CLIENT		
ABIB (OAMARU) LTD		
PROJECT		
GOODLAND COASTAL FARM		
TITLE		
EROSION & SEDIMENT CONTROL ADJACENT TO WETLAND		
DRAWN	TG	SCALE A1 1:25
DESIGNED	TG	A3 1:50
PROJECT No 1366	DRAWING No C227	REVISION A

To: Zoe Avery - The Urbanist
From: Zibo Yang - Crang Consulting
cc: Hari Hari - Goodland
Date: January 31, 2024
Re: 2127 Kaipara Coast Highway – Formal S92 Response – Rev 1

The following responses address items relevant to civil engineering within the Section 92 request letters. The queries responded to herein are cited in italics for ease of reference, with the corresponding response below. Each question retains the same number and wording as in the letter for ease of reference.

CLIENT	ABIB (OAMARU) LTD		
PROJECT	GOODLAND COASTAL FARM		
TITLE	ROADING TYPICAL CROSS SECTIONS SHEET 2		
DRAWN	MD	SCALE	A1 1:50
DESIGNED	VC	A3	1:100
PROJECT No	1366	DRAWING No	C321
REVISION	D

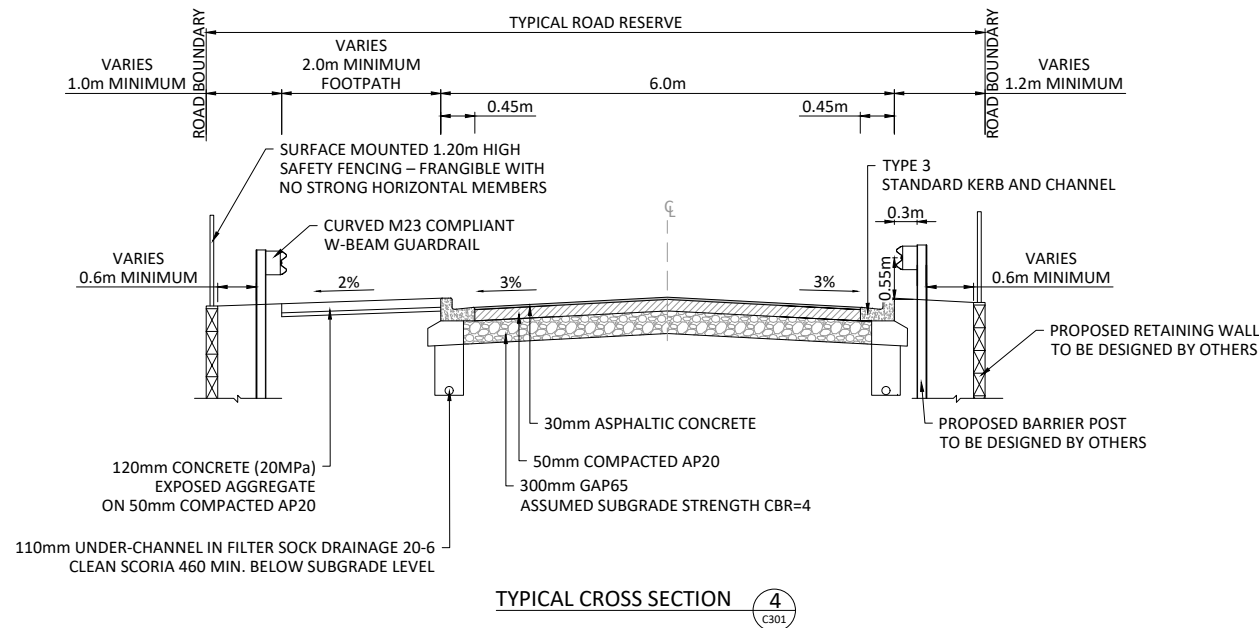
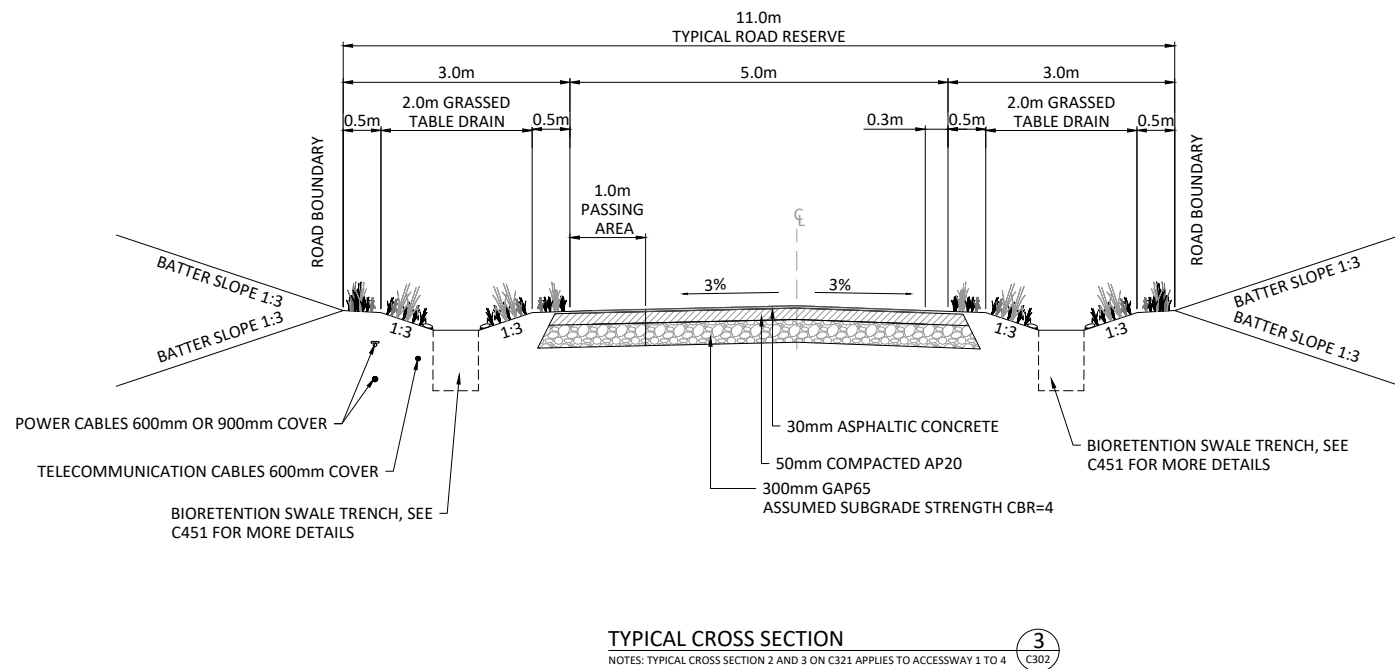
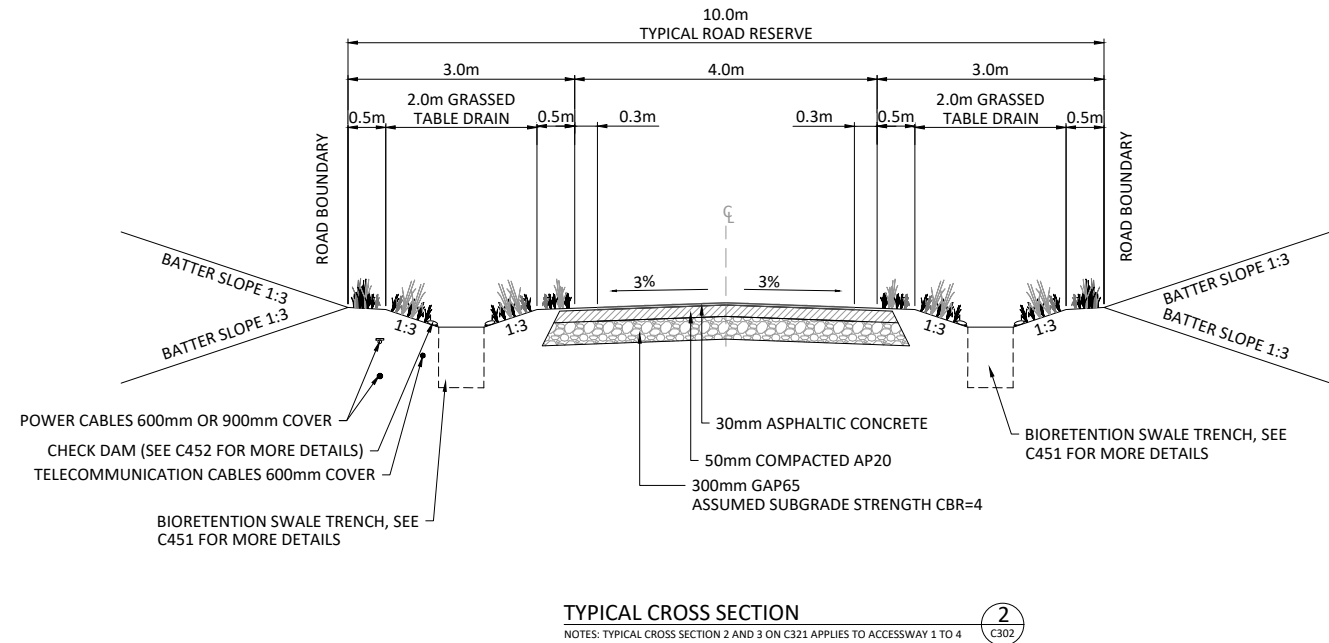
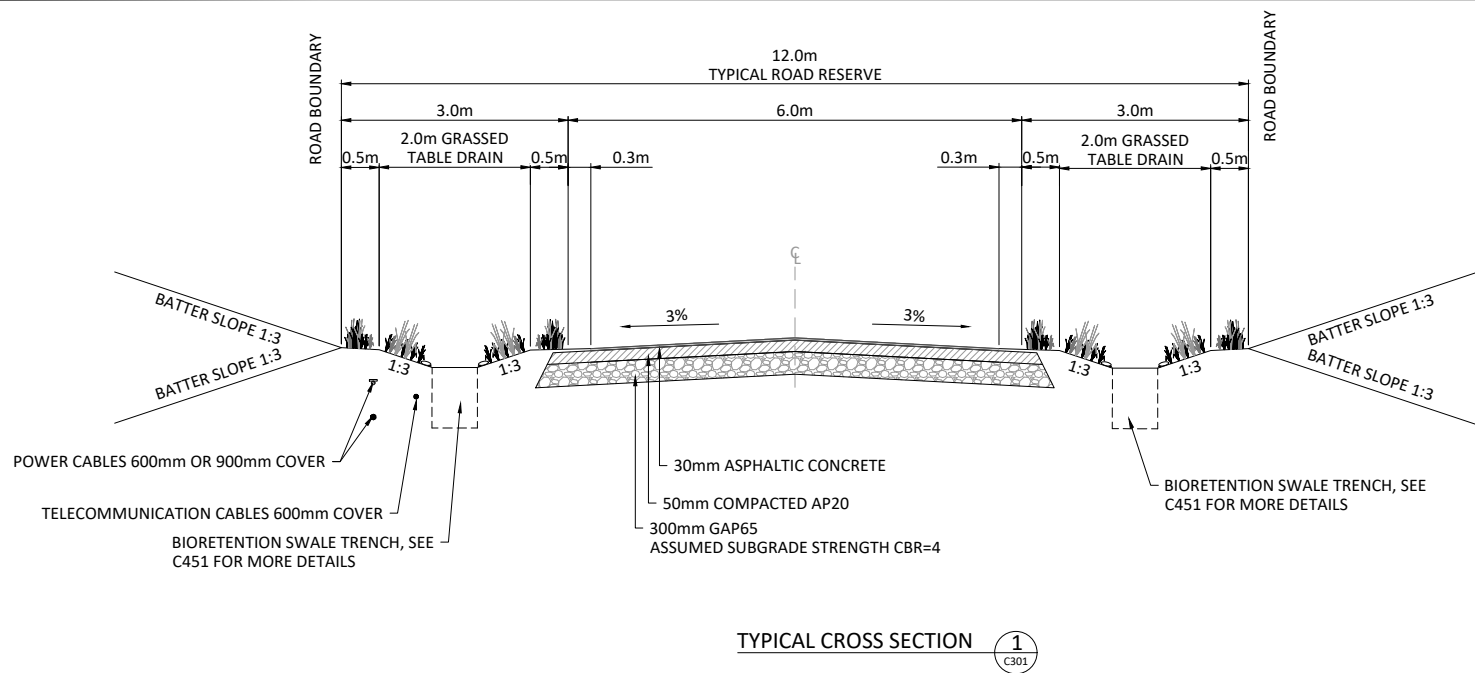
November 2023 comments: The response does not address the main purpose of this request. The request relates to the stabilisation of the access ways upon completion; and not the erosion control structure 'stabilised access way'.

It is proposed to seal the accessways within the development site with asphaltic concrete, refer to engineering plan 321 for further details.

DRAINAGE OVERALL PLAN

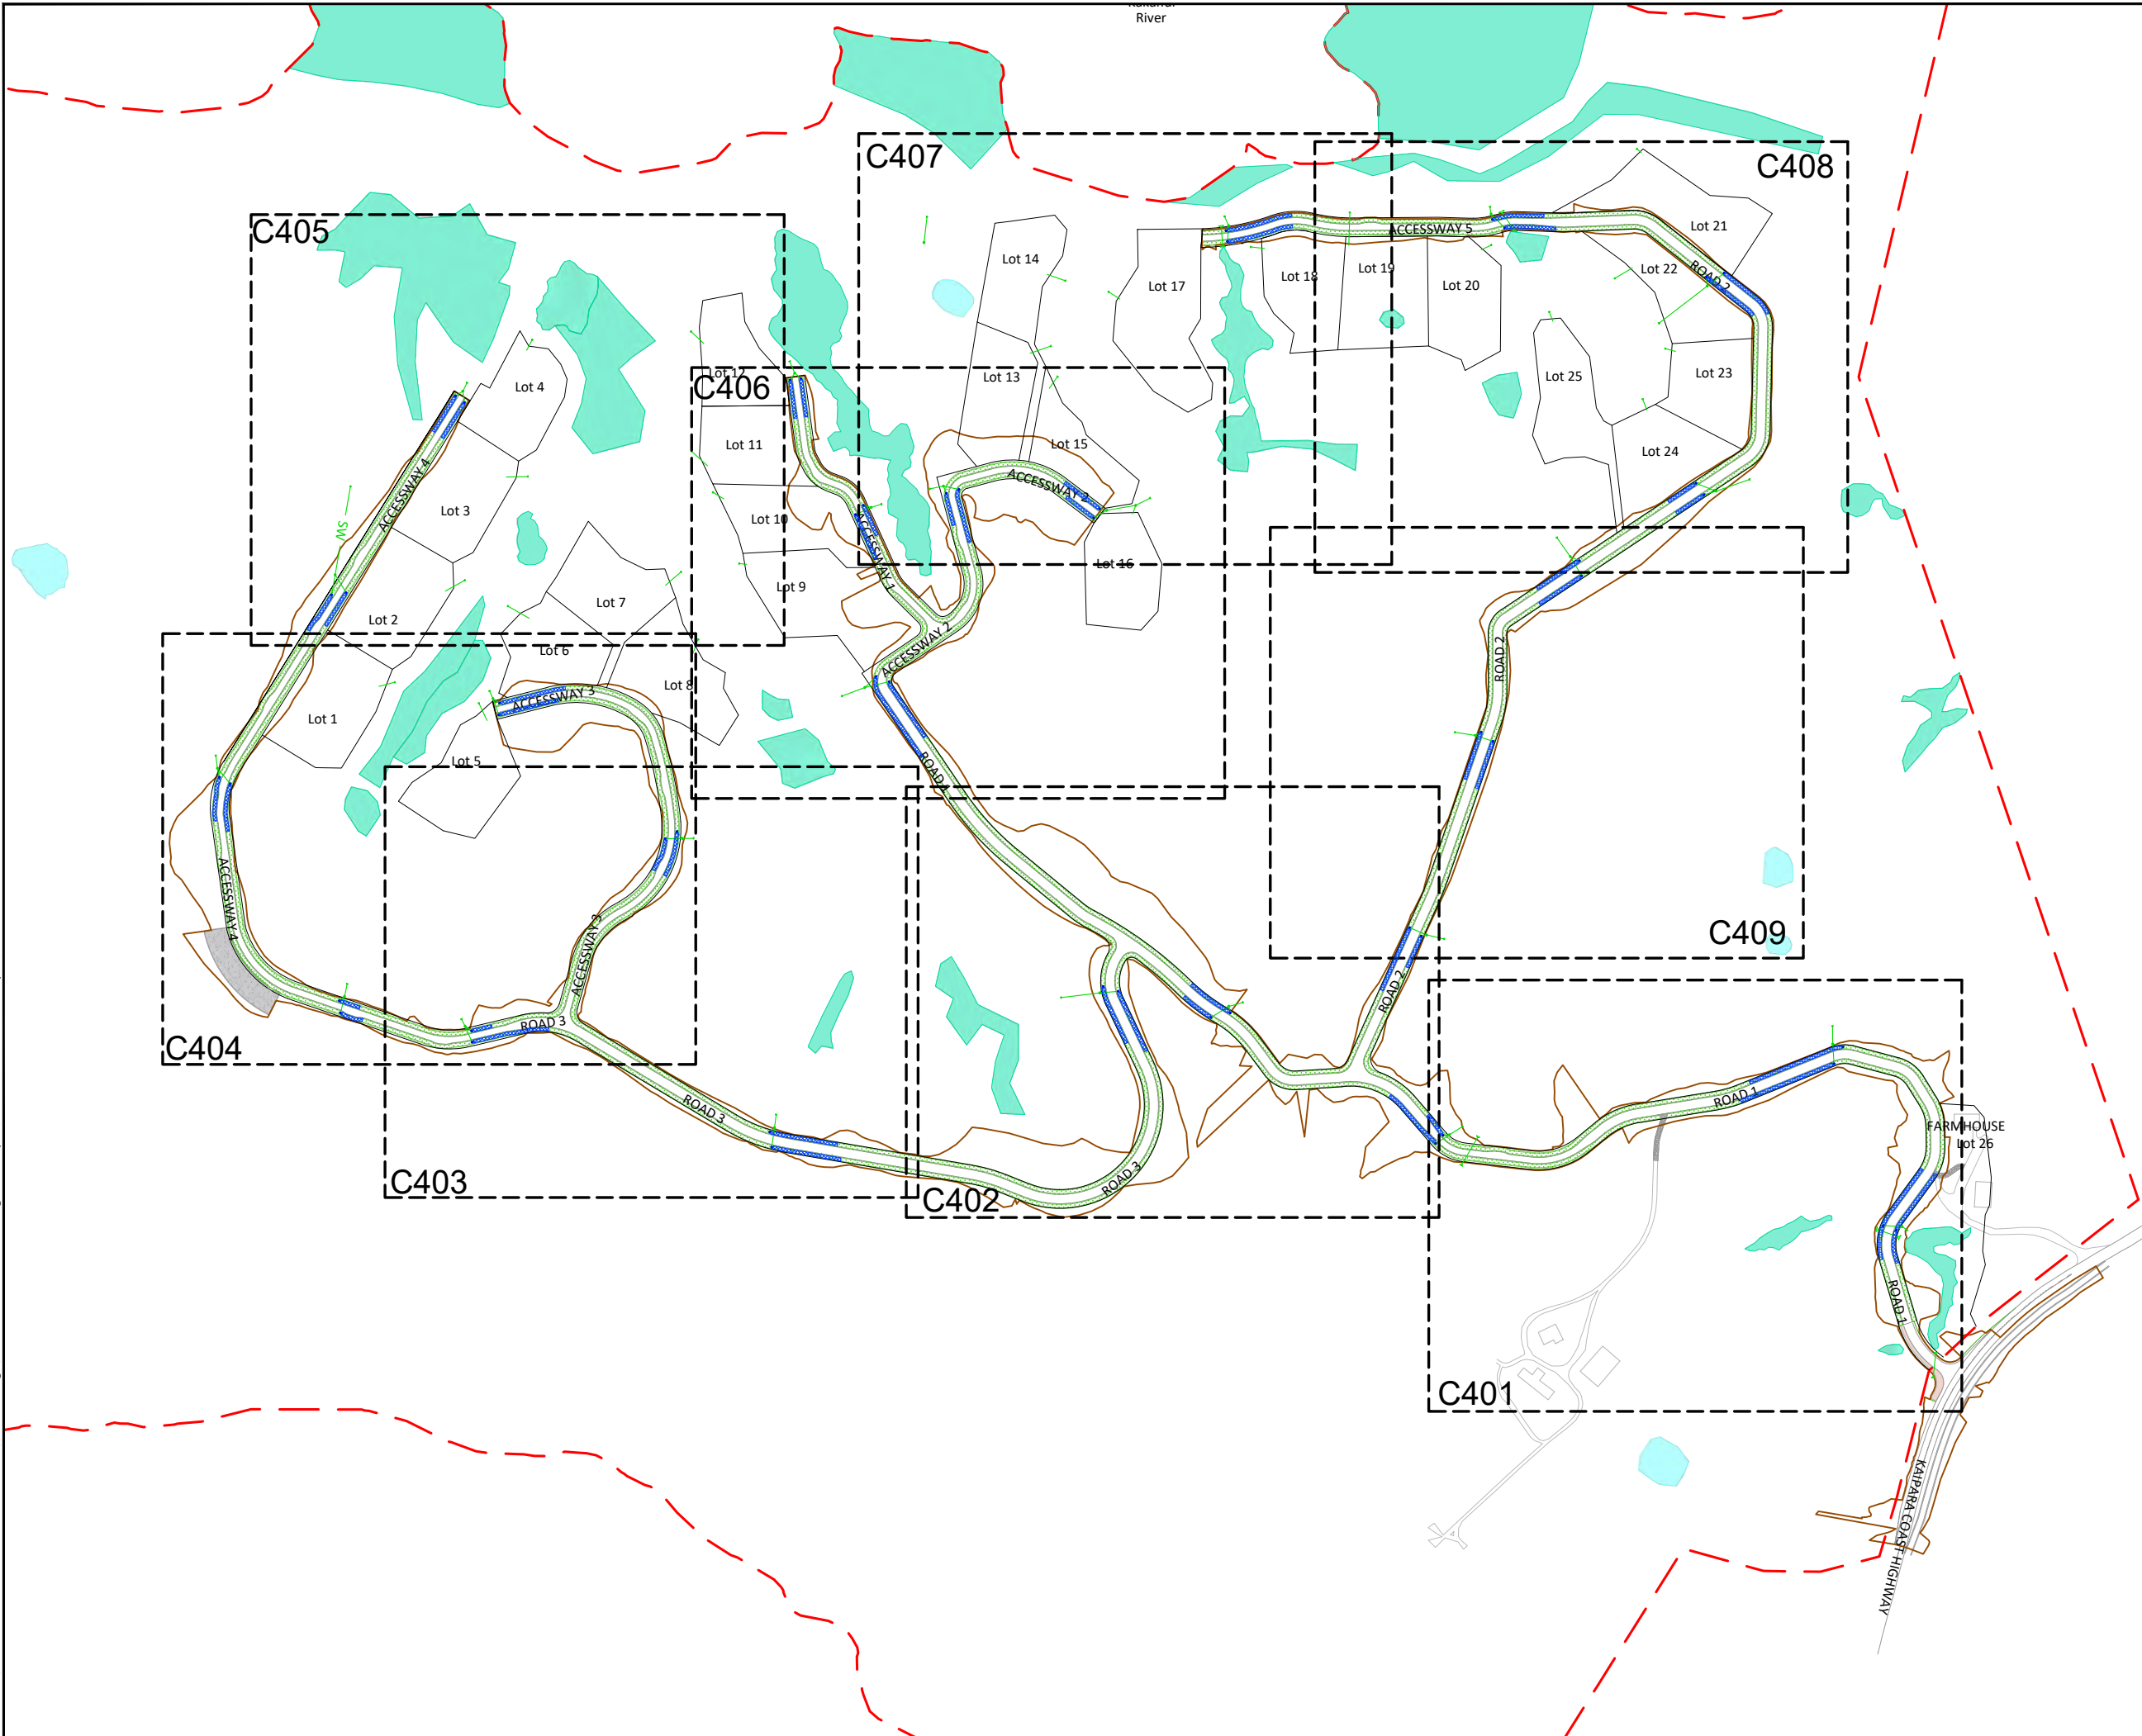
Query No. 3: We understand the roadside swales are purely for treatment and conveyance of road runoffs. In this case, please clarify if upstream flows will be intercepted and diverted so they can be directed into bypass culverts.

For clarification purposes, the stormwater infrastructures proposed for road drainage have been renamed, see the revised legends on drawings 400 series, the primary design function of each device is listed below:
